# **Land Use Application Summary Report**

Application Number:	SU 19-0305	Adjacent Zoning and Existing Land Uses:		
Request:	Special Use Permit for a Child Care Center	North:	ASC-1 / Vacant	
		South:	RSC-9-MH / Vacant (Day Care Center)	
Comp Plan:	RES-6 (Residential)	East:	PD 00-0532 / Single Family Homes	
Service Area:	Urban	West:	CN / Vacant

Pursuant to Land Development Code Section (LDC) Section 6.11.24, Child Care Centers, the request is for a Special Use Permit to operate a child care center on property located at 11308 S HWY 301 in Riverview.

Figure 2 – Proposed Site Plan

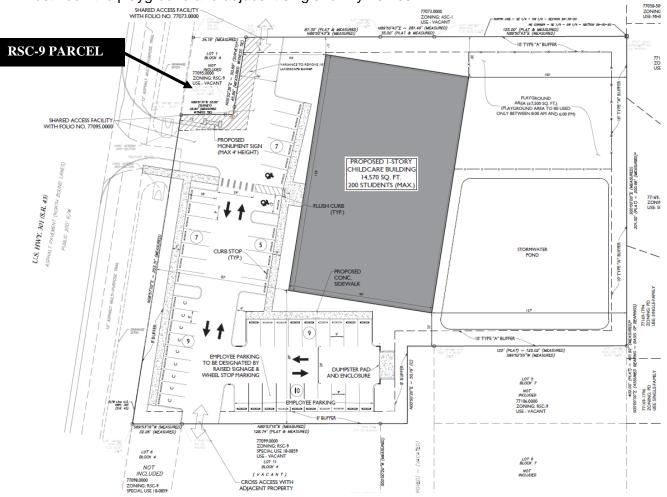
- Per LDC 6.11.24.A, Child Care Centers, "required patron parking shall be adjacent to the facility and clearly designated by raised directional signage and pavement or wheel stop markings. Each parking space shall be fronted with wheel stops set two feet from a continuous five foot wide sidewalk leading to the building entrance, or a raised curb and a continuous seven-foot wide sidewalk leading to the building entrance." The site plan shows this requirement being met. Parking adjacent to the building and sidewalks connecting to the facility entrance are shown on the plan.
- Per LDC Section 6.11.24.B, Child Care Centers, "employee and van parking shall be designated by raised directional signage and pavement or wheel stop markings." The employee parking areas are

shown on the site plan. These parking spots will be required to provide signage indicating that they are for employee use only.

- Per LDC Section 6.05.02, parking spaces required for the Child Care Center is 3.2 spaces per 1,000 square feet of gross floor area. The facility will have 14,570 square feet of gross floor area, therefore, a minimum of 47 parking spaces are required. The site plan submitted by the applicant shows compliance with this requirement.

- LDC Section 6.11.24.D, states that the use of outdoor play areas that are located within 100 feet of residentially zoned property shall be restricted to the hours between 8:00 a.m. and 7:00 p.m. The outdoor play area serving the proposed child care center will be located along the east of the site adjacent to properties zoned for residential uses (PD 00-0532). The applicant will restrict the hours of the play area as required by the LDC and will be screened and fenced. Per the submitted narrative and site plan, use of playground will be from 8:00 am until 6:00 pm. Additionally, the applicant has agreed that no loudspeakers will be utilized. A 10-foot-wide buffer area with Type A screening will be provided between the playground and adjacent single-family homes.

Per LDC Section 6.11.24.E-F, "the location and extent of the facility shall not adversely affect the
character of the existing neighborhood, and the Child Care Center shall be of a design, intensity and
scale to serve the surrounding neighborhood and to be compatible with the surrounding land uses and
zoning." Staff finds the proposed scale is compatible with the surrounding areas. Additionally, a similar
facility is currently approved south of the subject site. Entrance to the site would be from the west, off

US Hwy 301, an arterial roadway and commercial corridor. Cross access is being provided to the north and south as recommended by Transportation staff.

- The parcel adjacent to the south is zoned residential, however, the site has Special Use approval for a Child Care Center (SU 18-0859) and development plans are currently under review. Therefore, no principal use buffer is required between the two sites. An 8-foot-wide parking lot buffer will be provided.

- The parcel adjacent to the northwest corner is zoned RSC-9 as well. This parcel is approximately 2,000 square feet in size and is vacant today. As shown in the proposed site plan, the required 10-A buffer and screening is being eliminated adjacent to the RSC-9 parcel to accommodate future cross access to properties to the north and northwest. Therefore, the applicant has included a variance request in this Special Use application to eliminate the buffering and screening requirement, as described in Section 1.2 of this report. The hearing officer will be required to make a separate decision on the buffer variance in concert with this Special Use.

## 1.2 Variance Summary

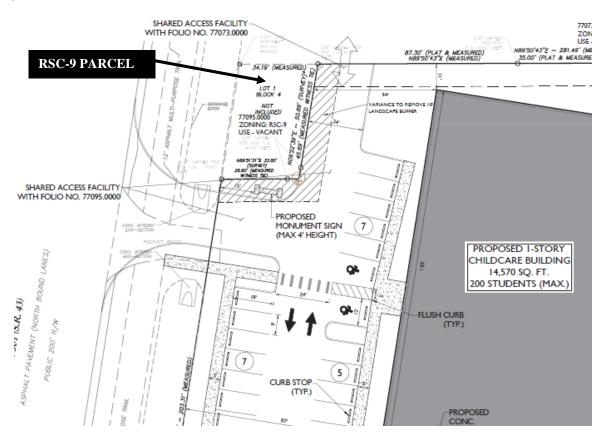
The applicant is requesting a variance from the LDC Section 6.06.06 - Buffering and Screening Requirements. The Hearing Officer will be required to rate the variance that is requested as part of the decision in this case.

Per the submitted site plan, the proposed Day Care site with accessory parking areas is bounded on the northwest corner by a vacant parcel zoned RSC-9. Per LDC Section 6.06.06, Buffers and Screening Matrix, the Day Care facility is considered a Group 4 use, while the vacant RSC-9 parcel falls within the Group 1 category. This instance would require a 10-foot buffer with Type A screening. The proposed site plan shows the required 10-foot buffer and screening being removed to accommodate a driveway serving as a future shared access facility to the adjacent RSC-9 parcel and the property to the north. Additionally, by eliminating the buffer along the south parcel line of the RSC-9 zoned property, a monument sign, 4 feet in height, would be placed as shown on the proposed site plan.
